Low Temp Test procedure for EVs

ACEA TF EV proposal (update)

**New version – discussed in SG EV call on December 11th
Including feedback/comments from SG EV members**

Test Procedure (BEV)

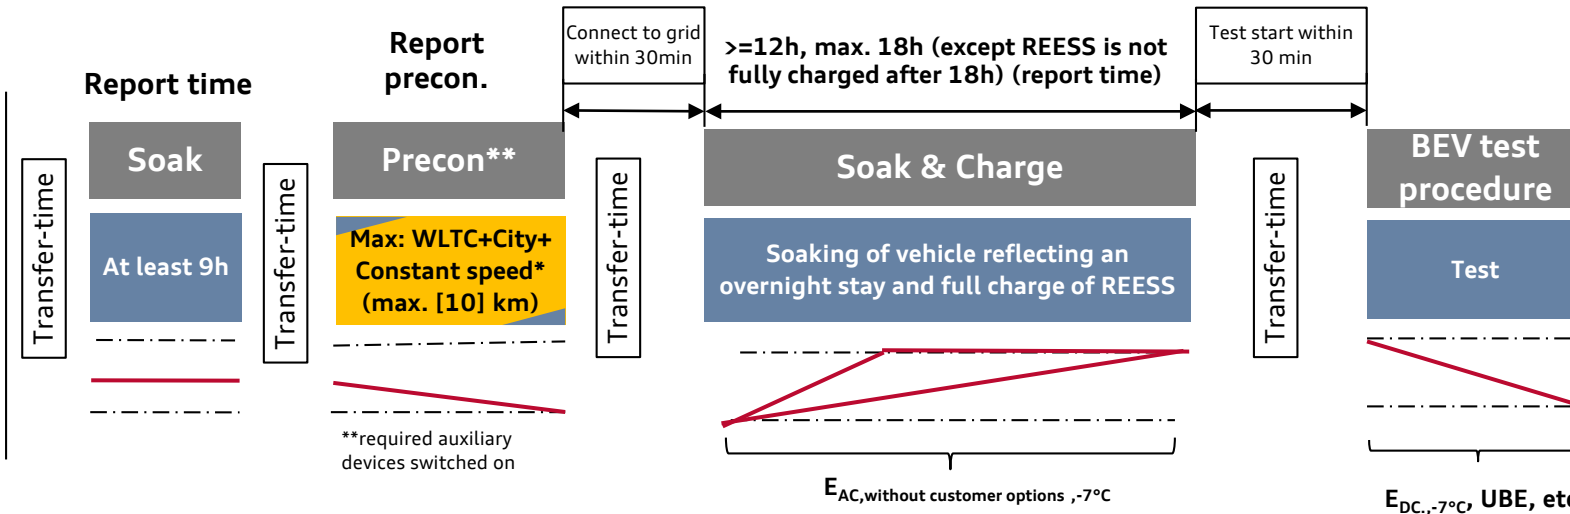
Feedback from SG EV web-audio 26.11.:

- More time and data are required
- To be discussed in a second step

Test Procedure (PEV) – Shortened Test Procedure or Consecutive Cycle Procedure

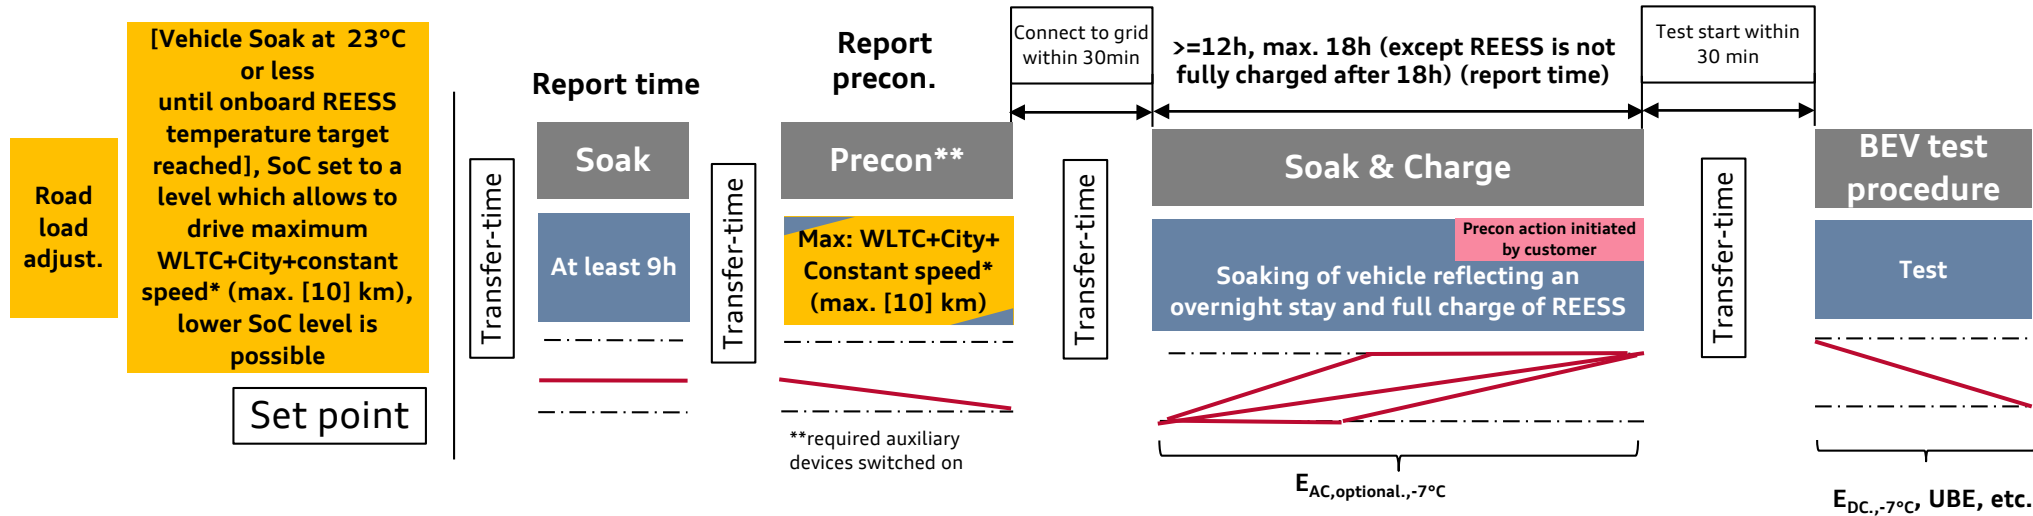
Feedback from SG EV web-audio 11.12.:

- Requirement necessary that the level of SoC at the end of preconditioning shall be "same" than after test procedure
- Preconditioning at 23°C: Further evidence needs to be given that this has no impact on the test result
- Constant speed during precon needs to be linked to constant speed in test procedure
- Break-off-criterion for precon shall be defined
- **Base procedure is mandatory and shall always need to be performed; optional procedure on next slides is only there for having procedure to evaluated the benefit of specific functions on the range value which will increase than**
- Focus on mandatory procedure and not on additional procedure for the moment

Test Procedure (PEV) – Shortened Test Procedure or Consecutive Cycle Procedure

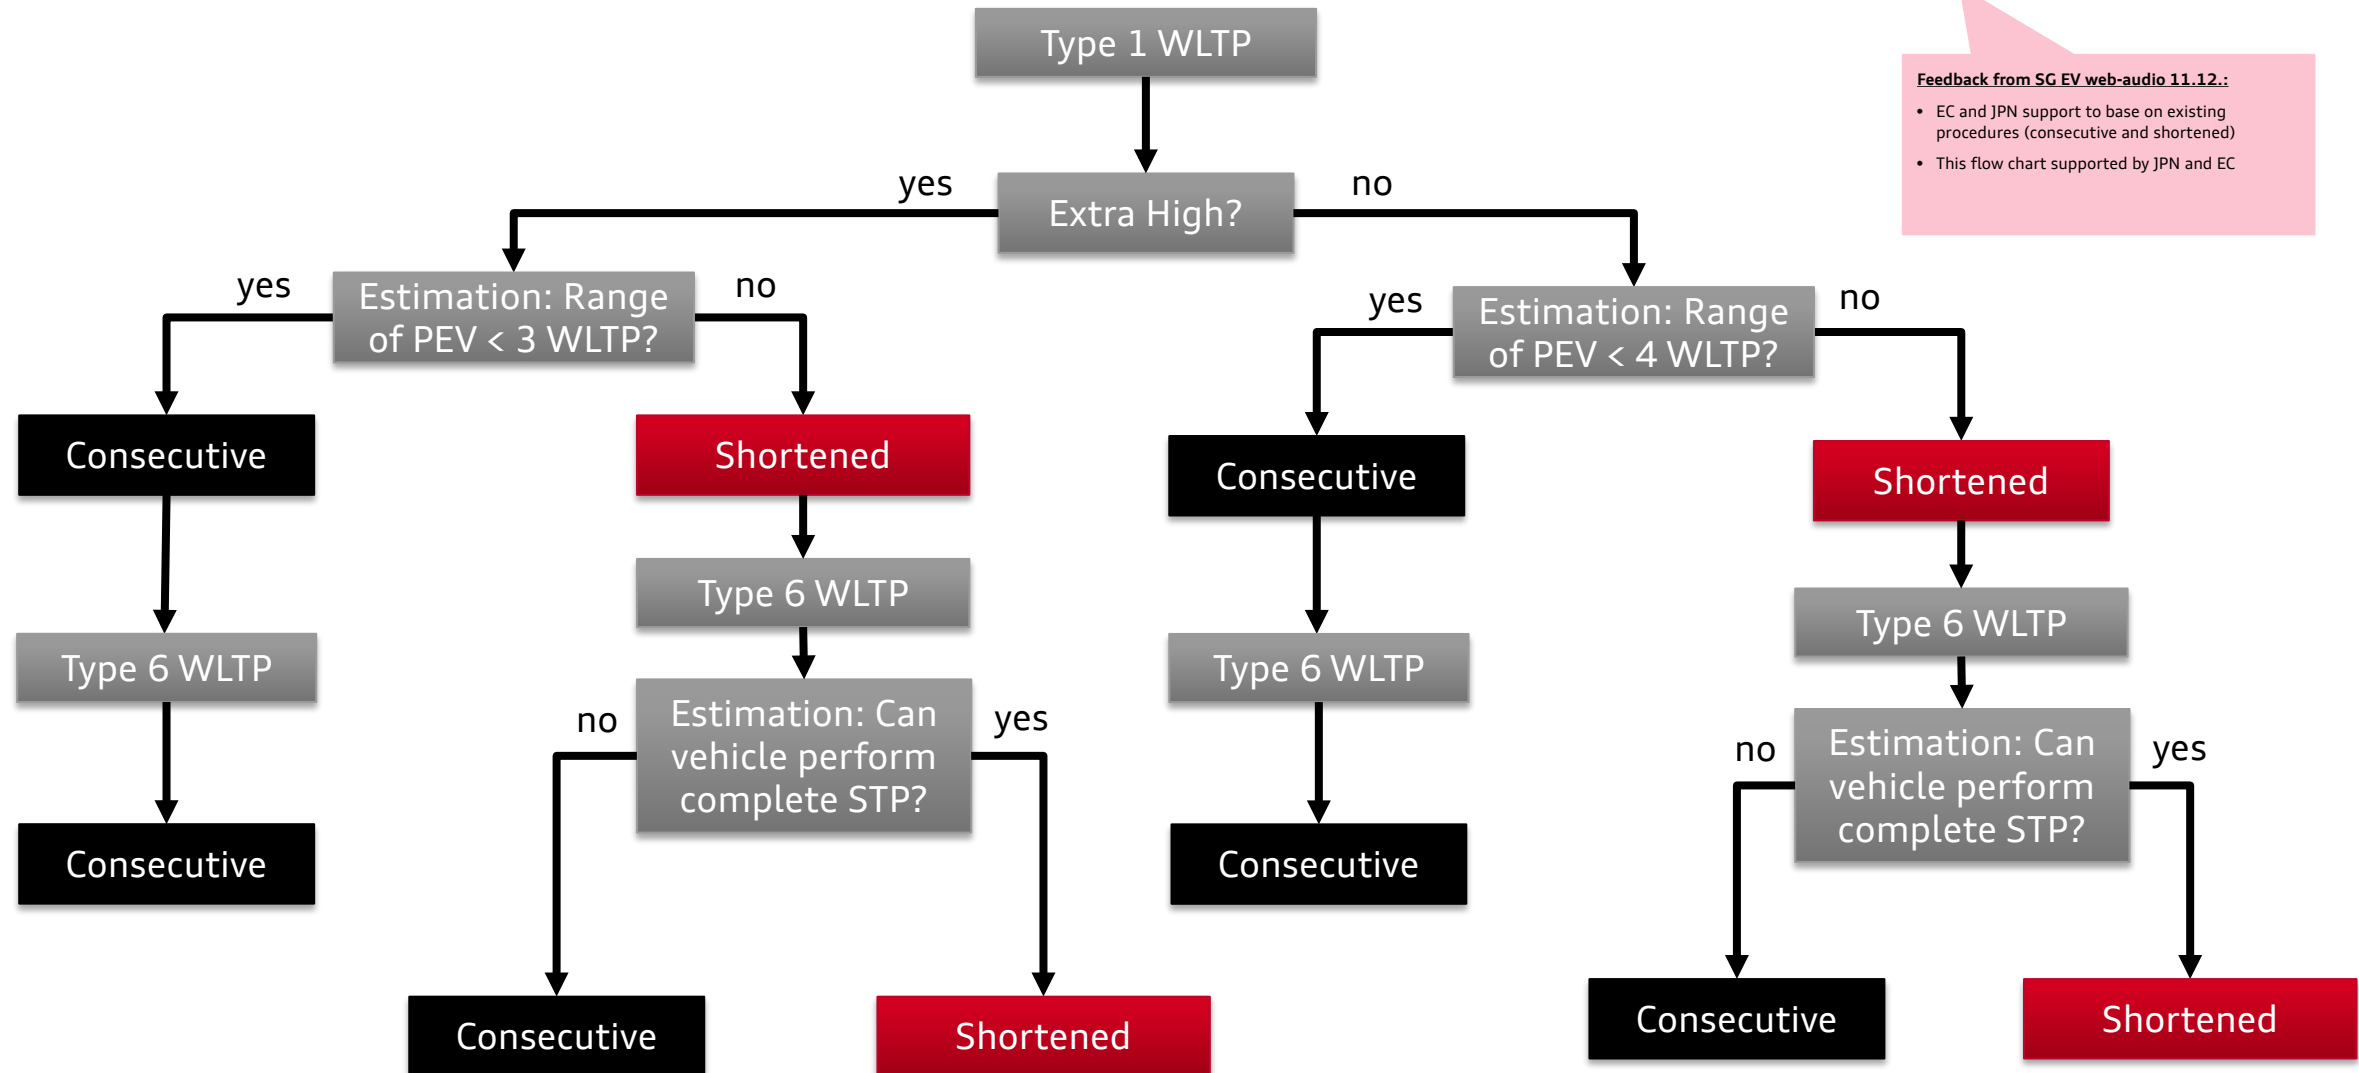
Feedback from SG EV web-audio 11.12.:

- Requirement necessary that the level of SoC at the end of preconditioning shall be "same" than after test procedure
- Preconditioning at 23°C: Further evidence needs to be given that this has no impact on the test result
- Constant speed during precon needs to be linked to constant speed in test procedure
- Break-off-criterion for precon shall be defined
- **Base procedure is mandatory and shall always need to be performed; optional procedure on next slides is only there for having procedure to evaluated the benefit of specific functions on the range value which will increase than**
- Focus on mandatory procedure and not on additional procedure for the moment

Test Procedure (OVC-HEV) – Charge Depleting Test

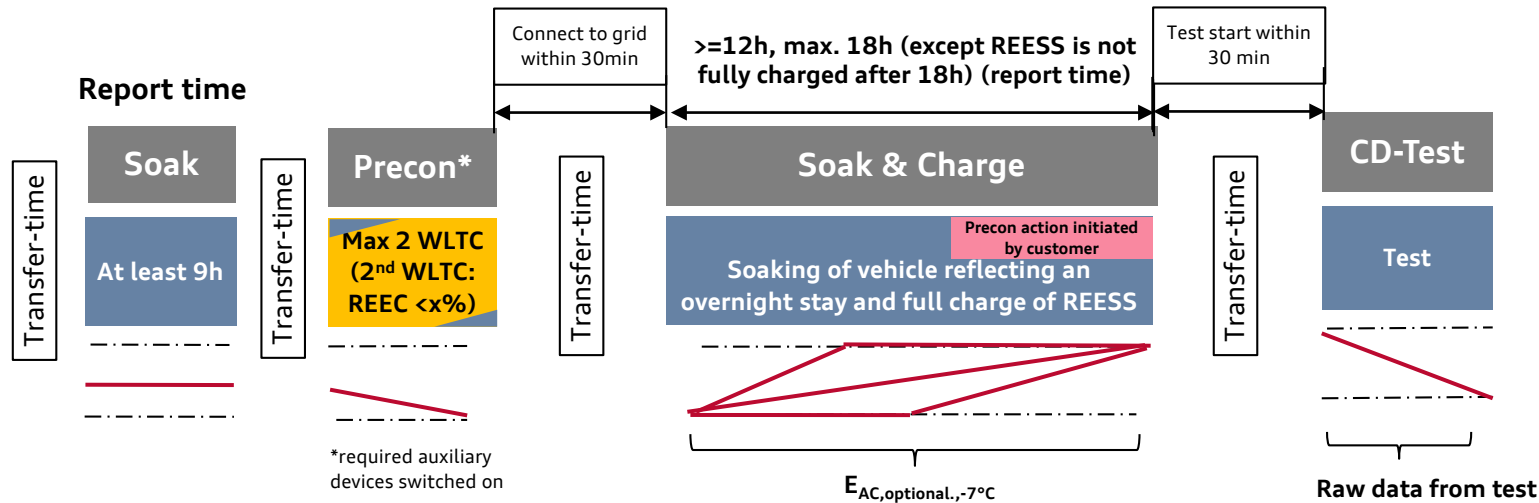
Feedback from SG EV web-audio 11.12.:

- Requirement necessary that the level of SoC at the end of preconditioning shall be "same" than after test procedure
- Preconditioning at 23°C: Further evidence needs to be given that this has no impact on the test result
- Base procedure is mandatory and shall always need to be performed; optional procedure on next slides is only there for having procedure to evaluated the benefit of specific functions on the range value which will increase than
- Focus on mandatory procedure and not on additional procedure for the moment
